Our Ref: A113720/PW  
Date: 14 October 2019

**REPRESENTATIONS ON BEHALF OF CARDIFF INTERNATIONAL AIRPORT LIMITED  
LAND AT MODEL FARM, PORT ROAD, RHOOSE  
APPLICATION REF: 2019/00871/OUT**

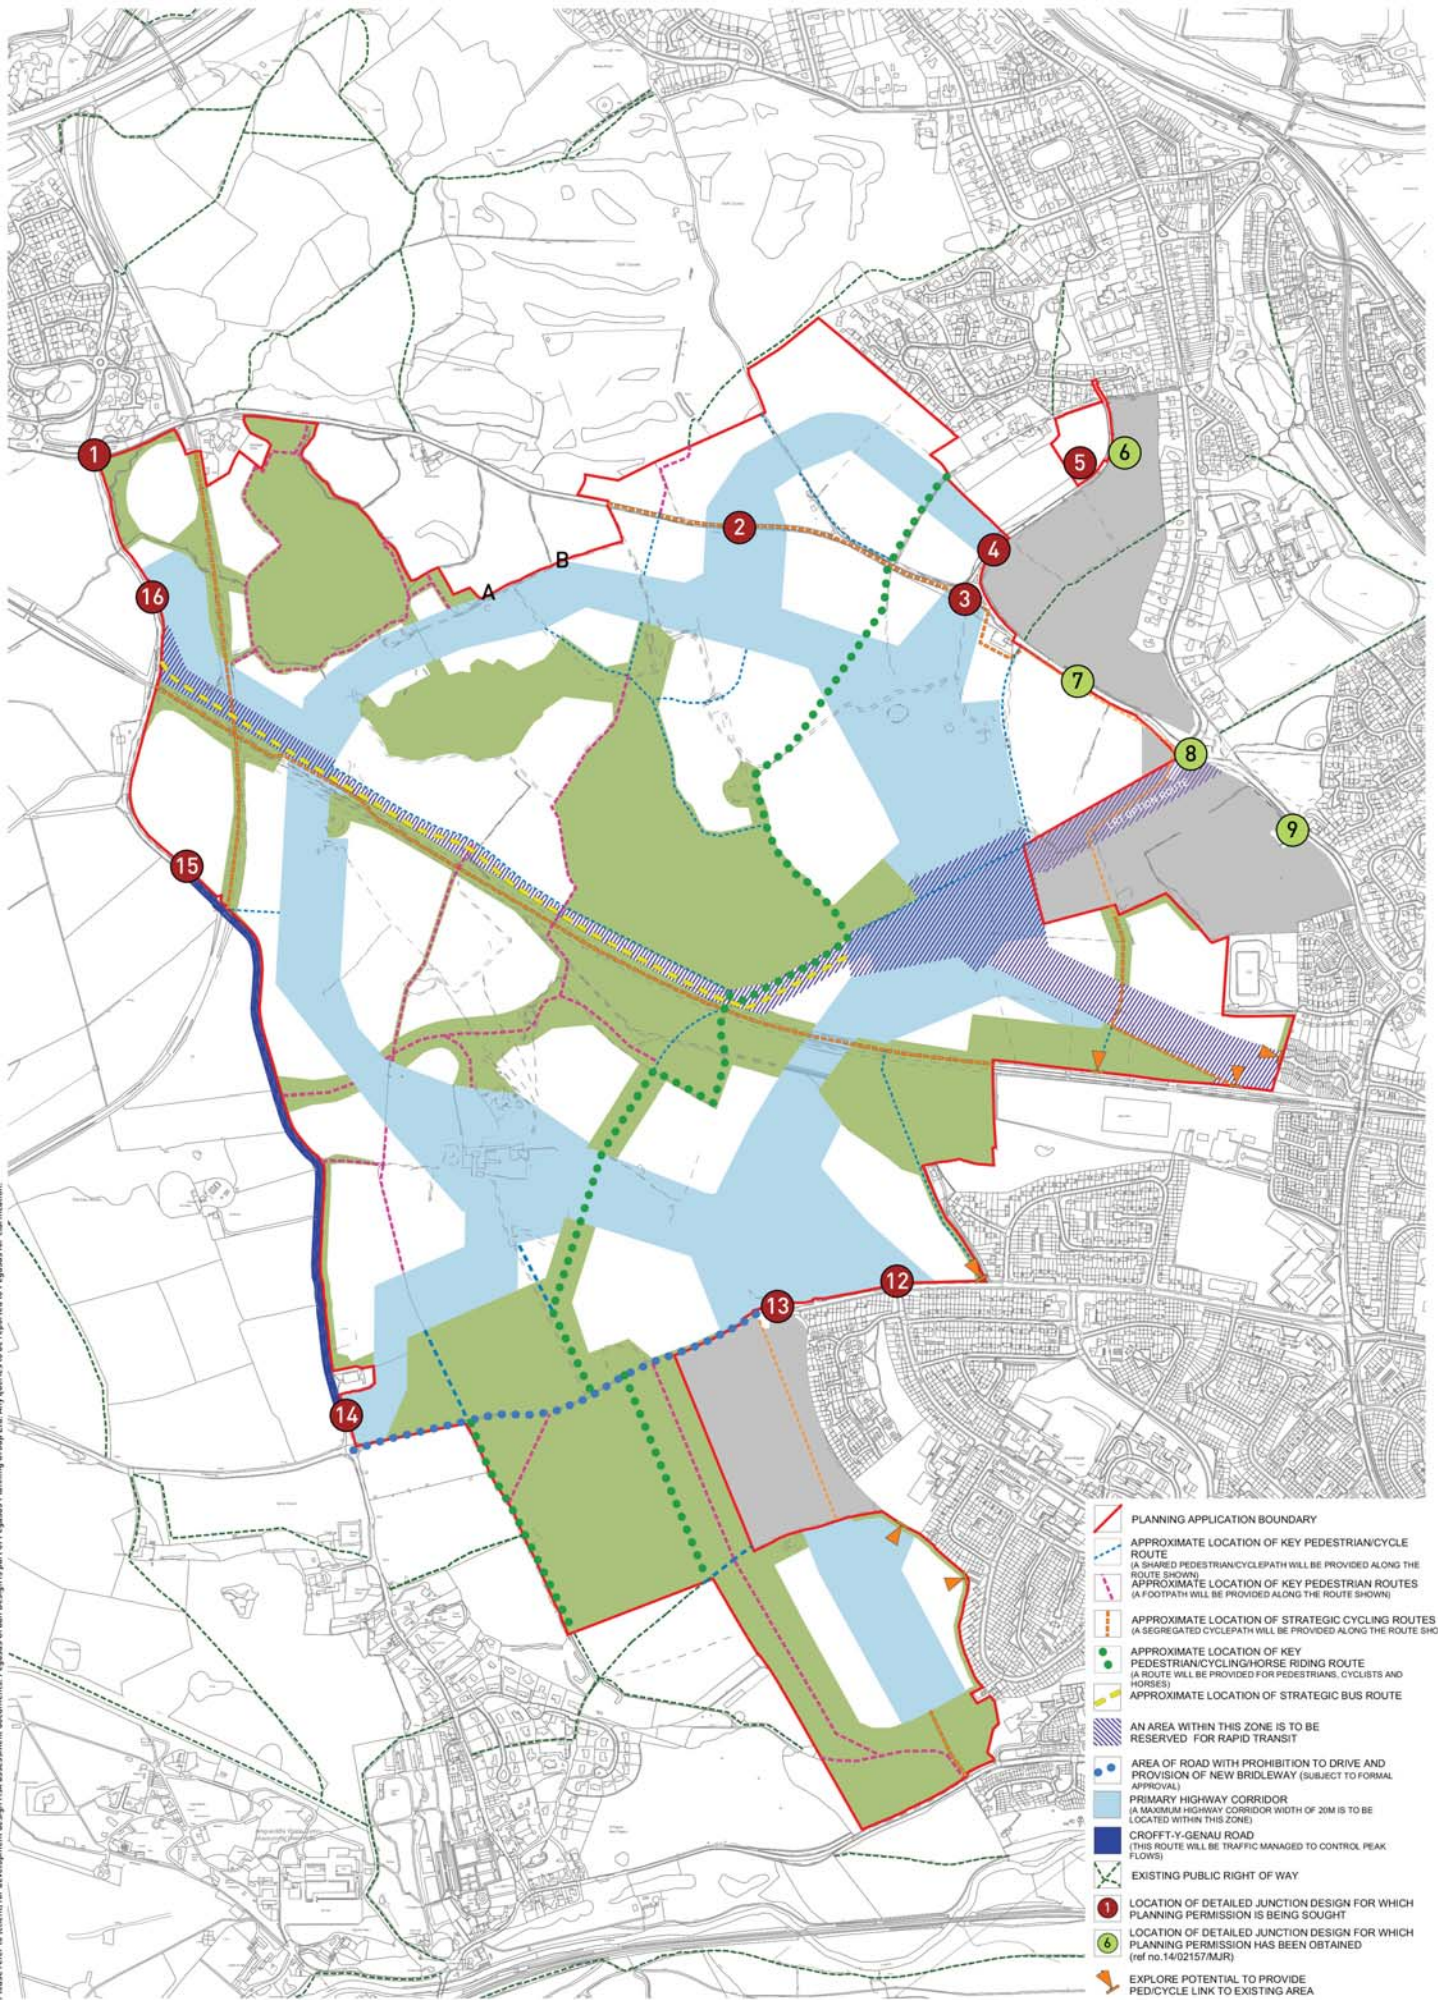
We attach the relevant access parameter plan referred to in part (b) of the condition which shows a zone to be reserved for rapid transit options. Your attention is drawn to the text on page 1 which confirms that *"A bus only route will be provided along the alignment of the rapid transport corridor before the LRT is delivered. This will provide express public transport at an early stage."*

Accordingly, it is clear that Cardiff Council did not have a precise corridor alignment at the time of LDP preparation or at the time of outline planning approval. The lack of detail at these stages did not prevent safeguarding of route options through the site and, wisely, the allowance of such routes to be used for alternative measures in the meantime (in the case of Plas Dwr the alternative use was a strategic bus route, but walking/cycling/ecology could equally be appropriate interim uses). Fundamentally, the safeguarding of route options in the absence of a definitive alignment were not seen to be inimical to the grant of a beneficial planning permission.

Accordingly, our client objects to the application in its current form due to the absence of route safeguarding option(s) for a potential future rail link.
